ADDENDUM NUMBER 1

PROJECT: Alpine Road Culvert Replacement

CONTRACT NUMBER: SD-2020-04

ENGINEER: Horvath Associates, P.A.

# 2431 ALPINE ROAD DRIVEWAY PLAN

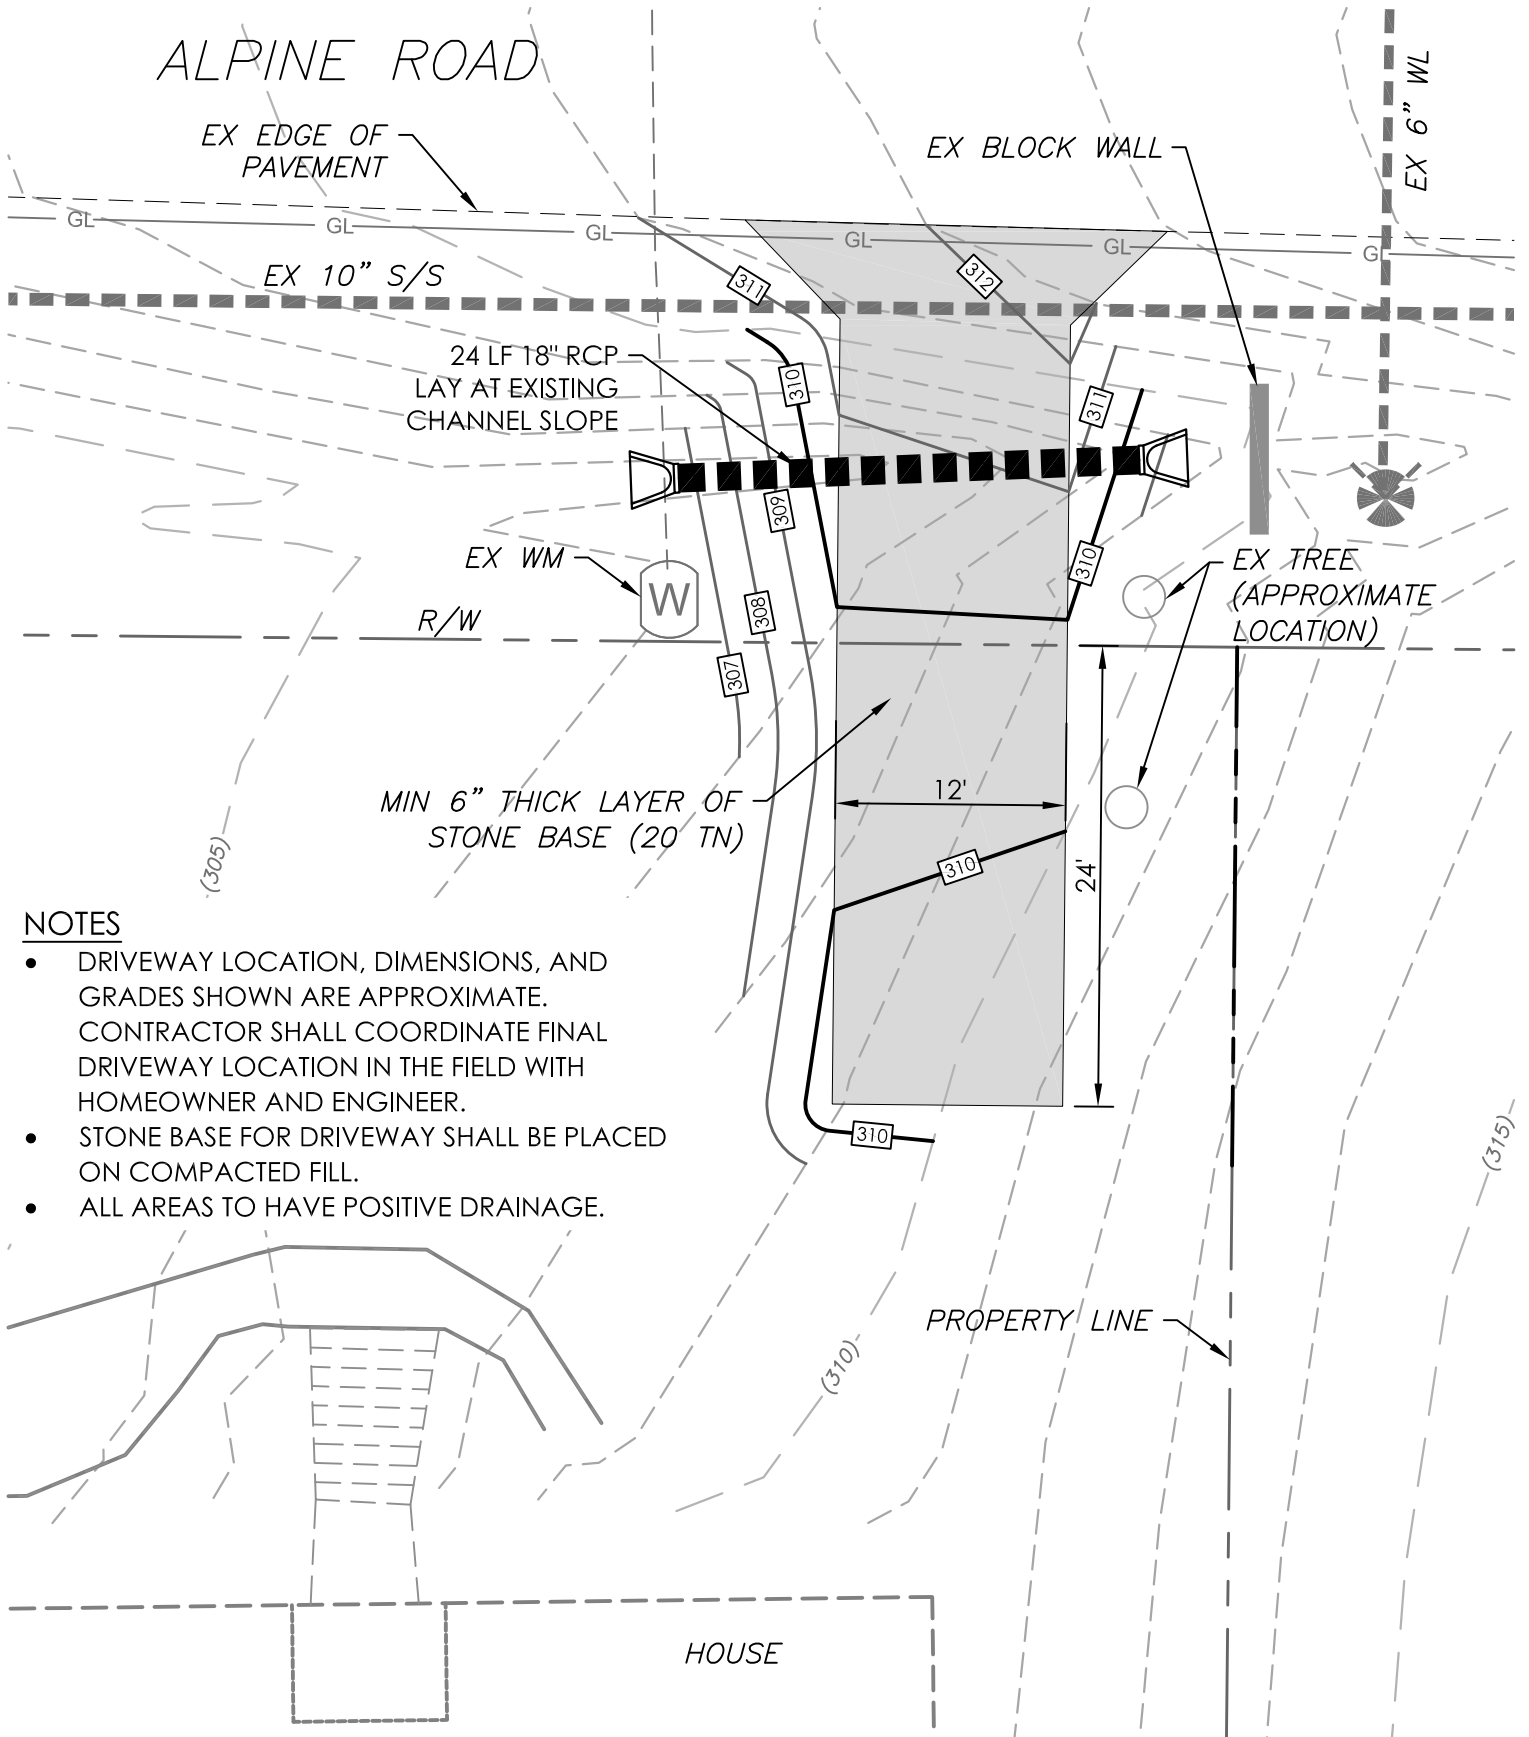
7. The LIST OF DRAWINGS included in document 00 31 00, dated January 13, 2020 includes the correct and updated Drawings included in this Contract. The Drawings may be downloaded from the Project web page: <https://durhamnc.gov/3909>.
  - a. Drawing “2431 ALPINE ROAD DRIVEWAY PLAN”, dated 01/13/2020 was added to the LIST OF DRAWINGS and is included with this addendum.
    - i. A second permanent driveway is being added to the project to allow access to the property at 2431 Alpine Road. Additional Unit Price Work quantities have been included in the UNIT PRICE WORK FORM.

- DRIVEWAY LOCATION, DIMENSIONS, AND GRADES SHOWN ARE APPROXIMATE. CONTRACTOR SHALL COORDINATE FINAL DRIVEWAY LOCATION IN THE FIELD WITH HOMEOWNER AND ENGINEER.
- STONE BASE FOR DRIVEWAY SHALL BE PLACED ON COMPACTED FILL.
- ALL AREAS TO HAVE POSITIVE DRAINAGE.
